LORSON RANCH AT JIMMY CAMP

SKETCH PLAN AMENDMENT No. 2 LETTER OF INTENT

Vicinity Map

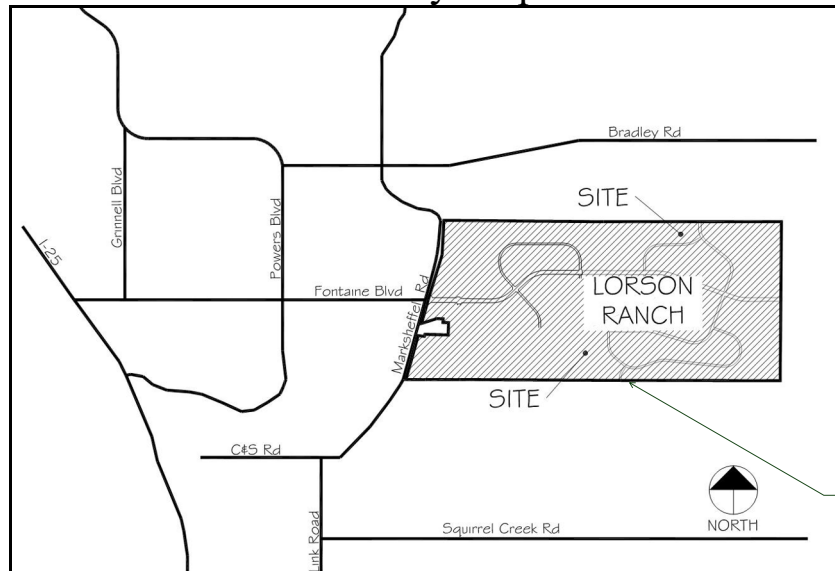
remove the connection road; modify the location of the sites...the entire development is apart of the app with secific clouded (proposed changes)
